附帶規劃文件

用途： 「擬議臨時公眾停車場(貨櫃車除外)和相關填土工程(為期 3 年)」

Drainage Proposal Report

Responses to Comments from Government Departments on Planning Application No. A/YL-PH/996 (refer to Planning Department letter of 2 January, 2025)

DRAWING No.
FIGURE 2

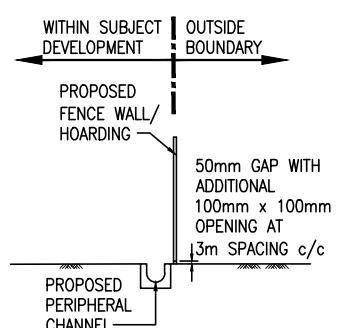
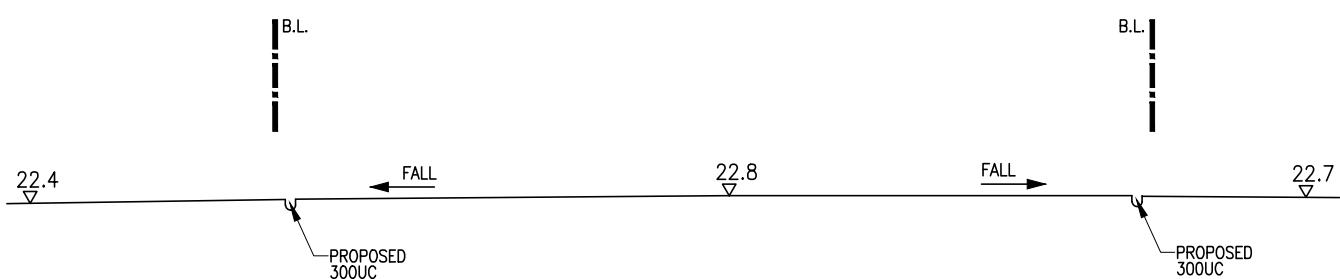
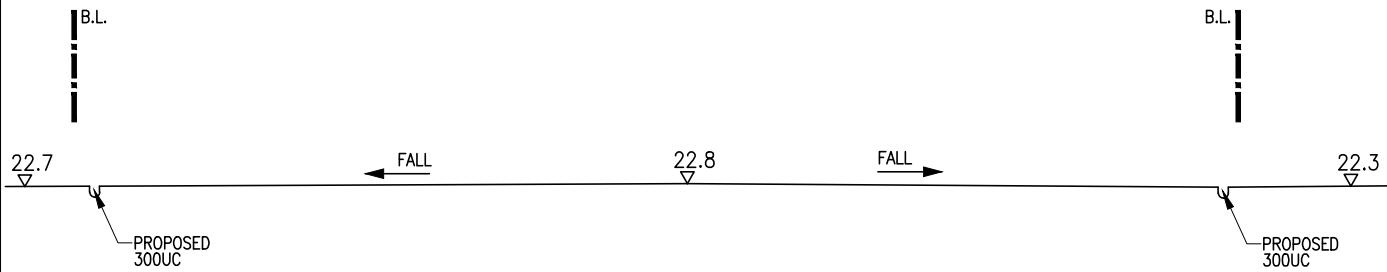
(4) The applicant is required to consider to replace the proposed 150 u-channel from point A to CP1 by a 225 u-channel.	Amended accordingly.
(5) The C.L. of channels/catchpits should be indicated in Figure 2.	Added accordingly.

FIGURE 4

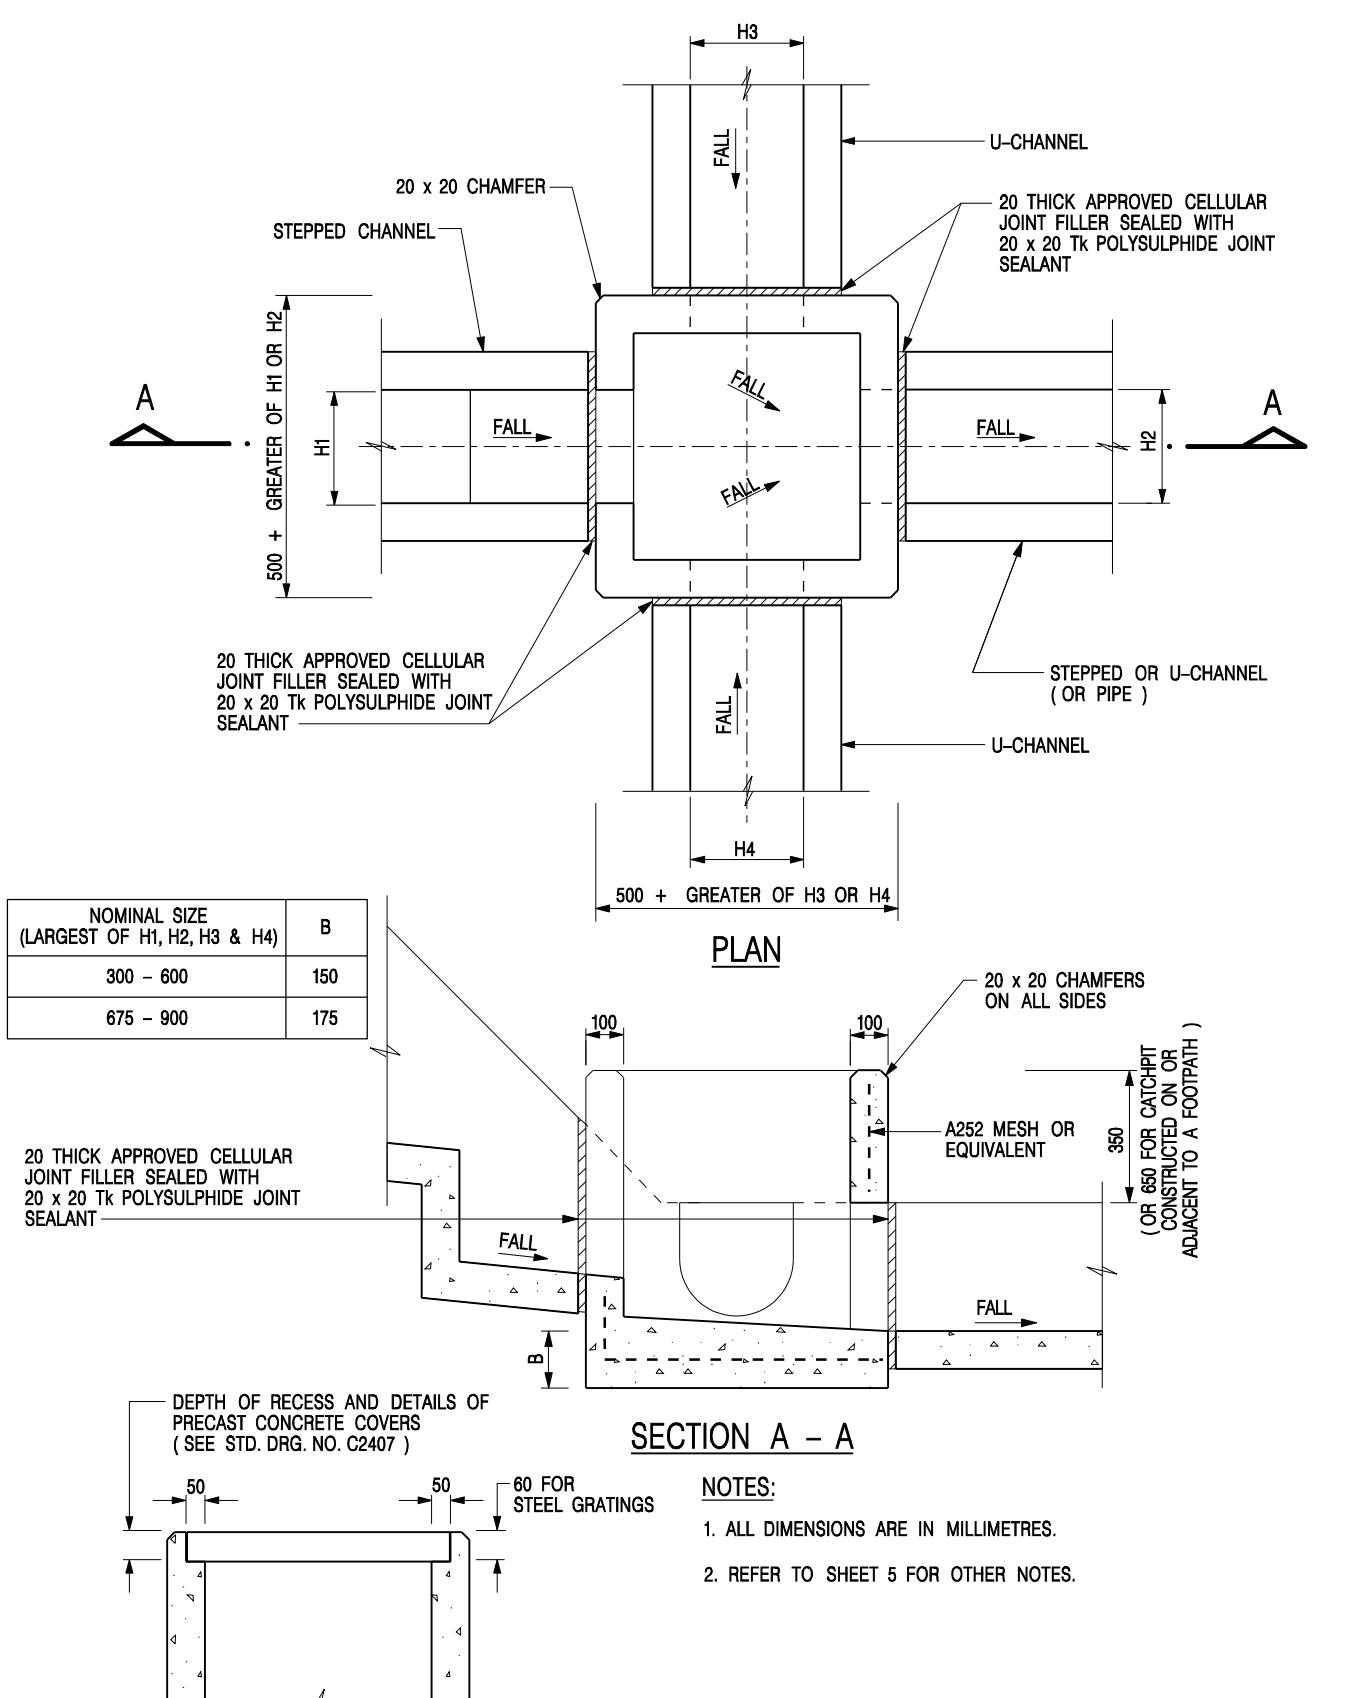
(6) The C.L., I.L. and B.L. at discharge point should be shown in Figure 4.	Added accordingly.
